# Comment #69 TX Lower PSD Mask

**Tim Baggett**  
IEEE 802.3da Task Force, July 2024

# Comment #69 – Constrain Lower TX PSD Mask

OLD

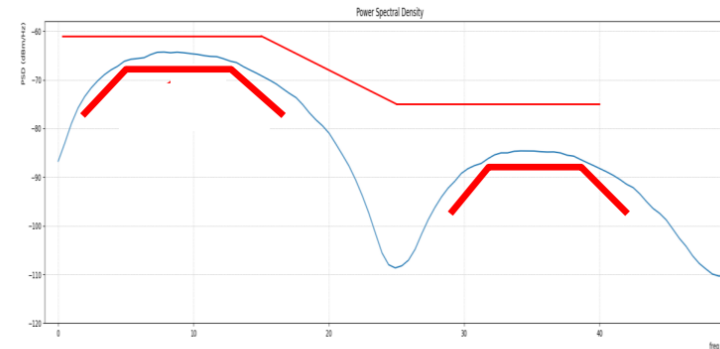
- The lower PSD mask has been shown to be too loose
  - See: IEEE 802.3da – EMC Noise Margin, Piergiorgio Beruto, July 2022
    - [https://www.ieee802.org/3/da/public/1122/beruto\\_3da\\_20221114\\_emc\\_noise\\_margin.pdf](https://www.ieee802.org/3/da/public/1122/beruto_3da_20221114_emc_noise_margin.pdf)
- Proposed changing first lobe PSD:

$$\text{Lower PSD}(f) = \begin{cases} -77 + 4*(f-2.5) & 2.5 \leq f < 5 \\ -67 & 5 \leq f < 12.5 \\ -67 - 2.5*(f-12.5) & 12.5 \leq f \leq 16.5 \end{cases}$$

} dBm/Hz,  $f$  in MHz

## Clause 147 TX Mask

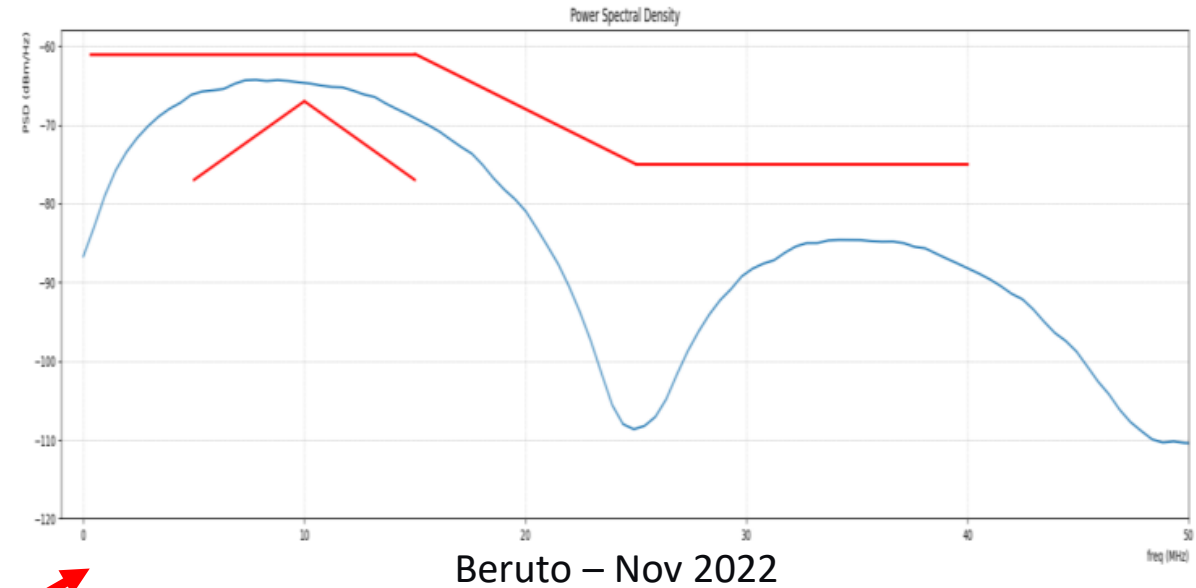
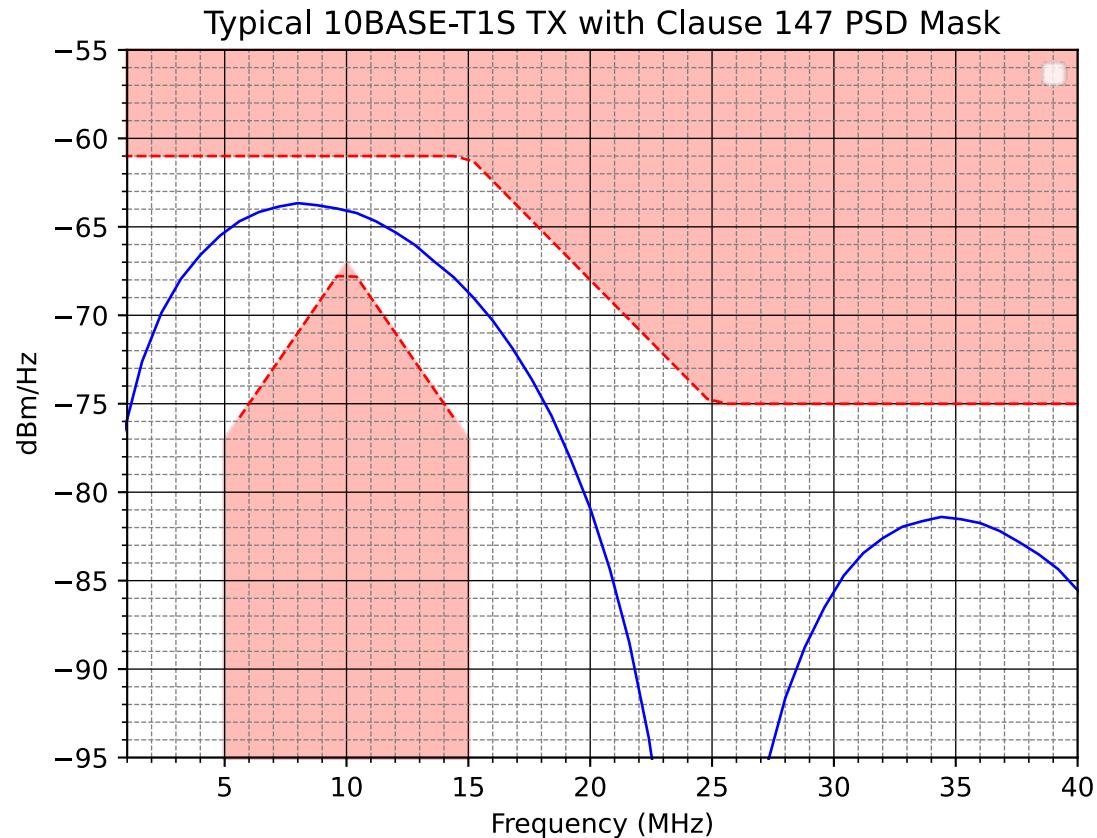
- Compares to Beruto (Nov 2022)
- Good Margin

## Comment #69 Proposed TX Mask

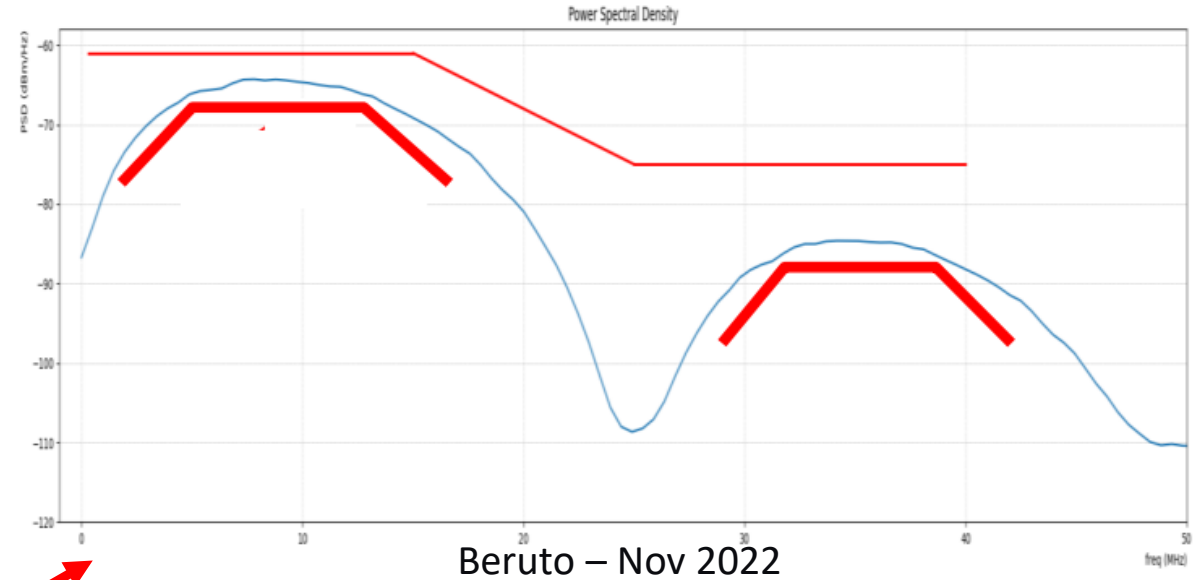
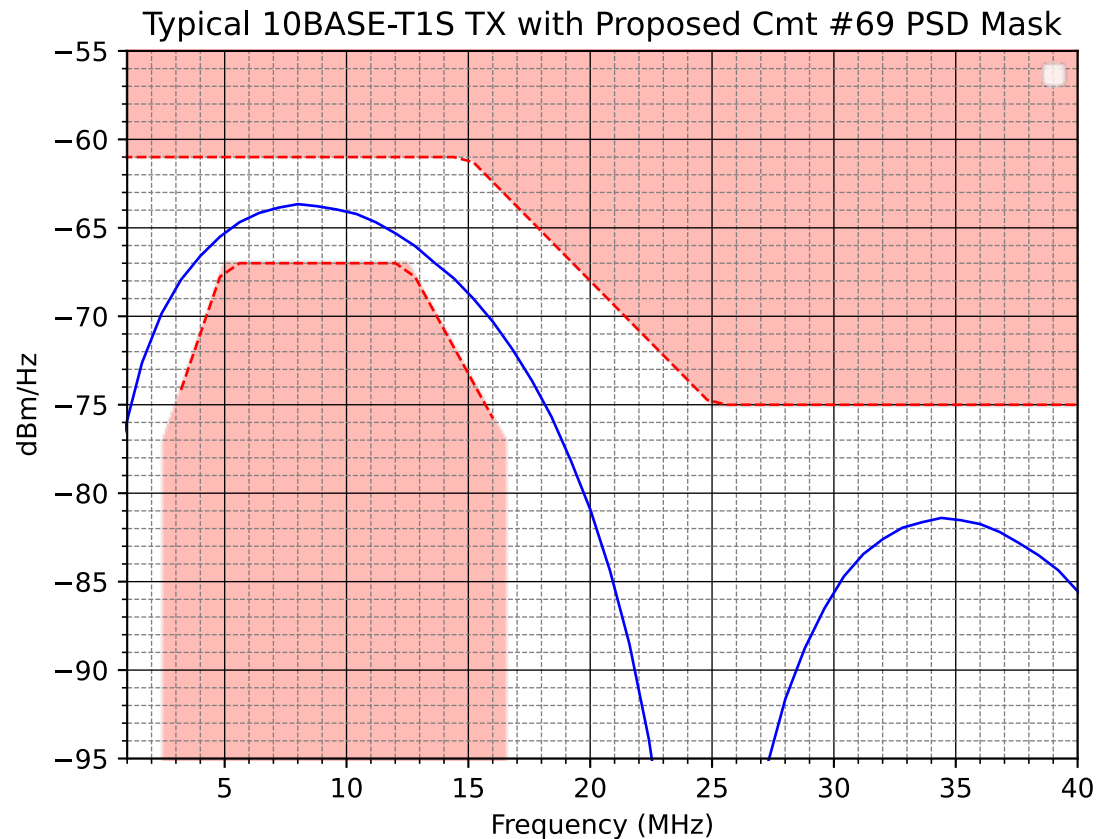
- Close at 5MHz, 12.5Mhz with *typical* TX

Comment #69 Proposed Lower TX PSD Mask  
versus 880mVpp - 1.2Vpp Differential Amplitude

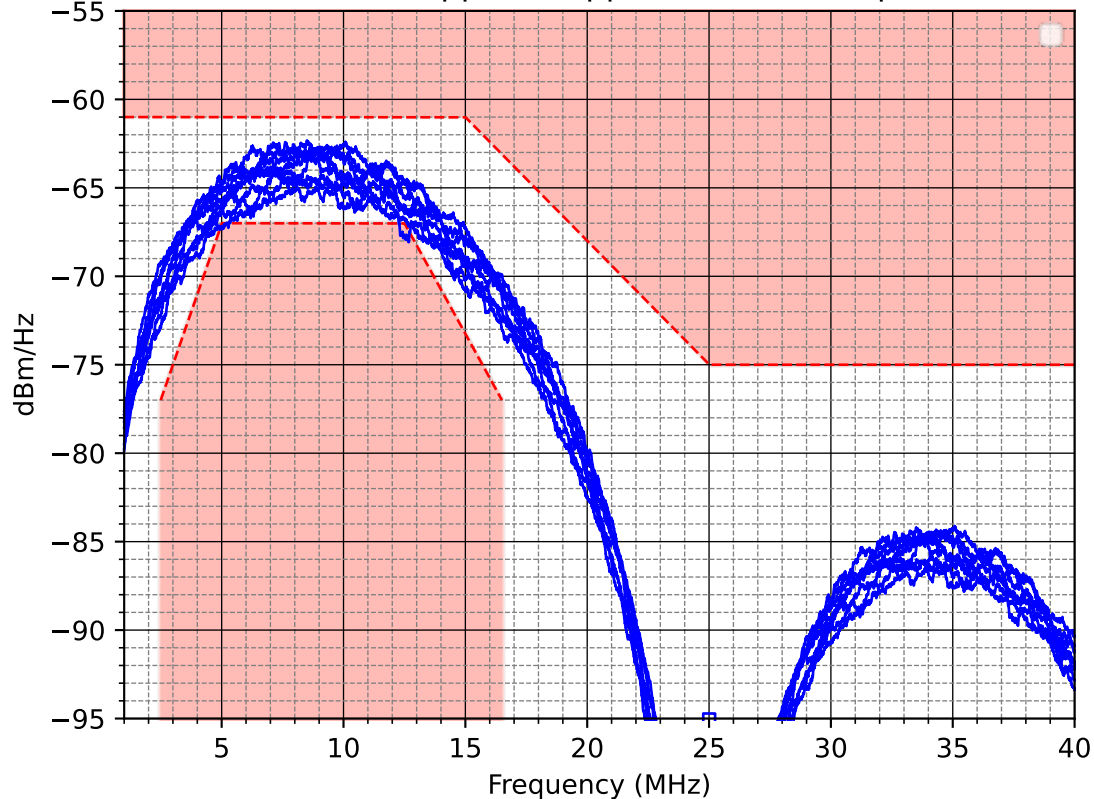
- Now we do have a problem at 5MHz, 12.5MHz
  - This is still *above* the minimum 800mVpp amplitude

# Relax the Lower TX PSD as proposed in Cmt #69

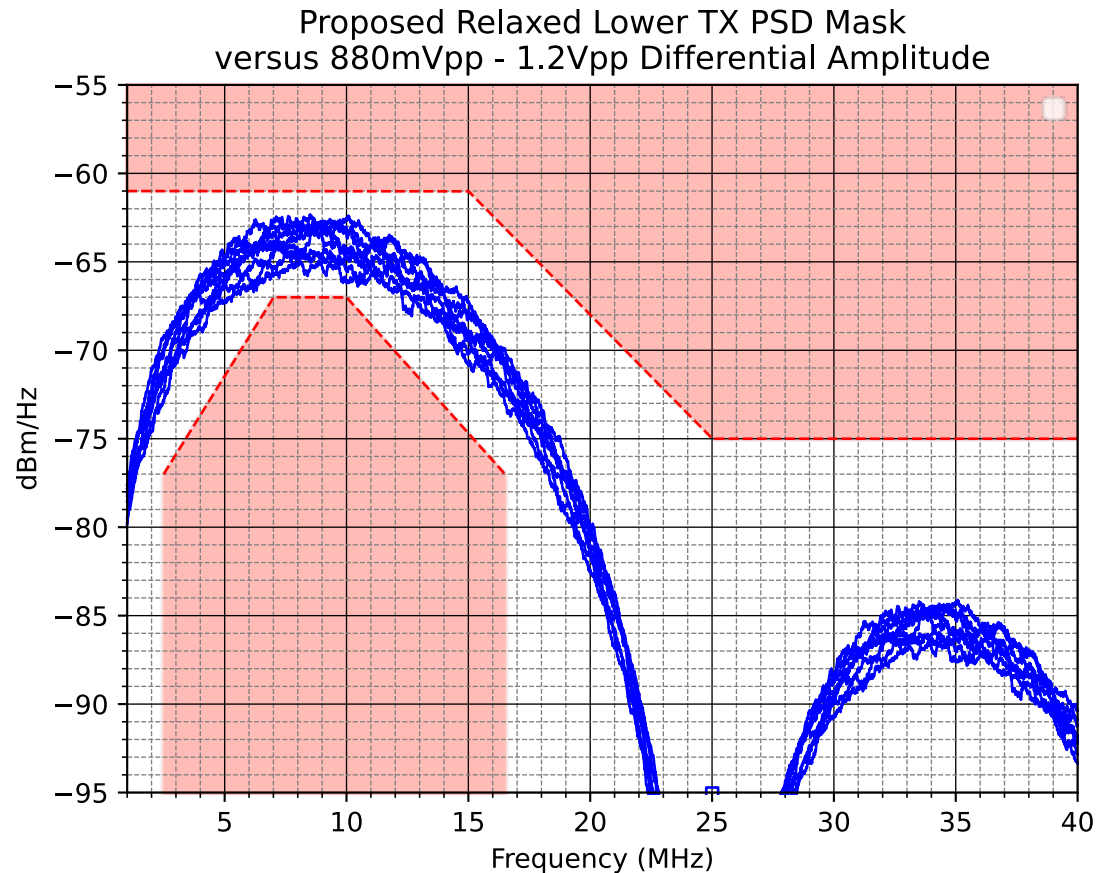
- Increase lower cutoff from 5MHz to 7MHz
- Decrease upper cutoff from 12.5MHz to 10MHz

$$\text{Lower PSD}(f) = \begin{cases} -77 + (10/4.5)*(f-2.5) & 2.5 \leq f < 7 \\ -67 & 7 \leq f < 10 \\ -67 - (10/6.5)*(f-10) & 10 \leq f \leq 16.5 \end{cases} \text{ dBm/Hz,}$$

where  $f$  is in MHz;  $2.5 \leq f \leq 16.5$
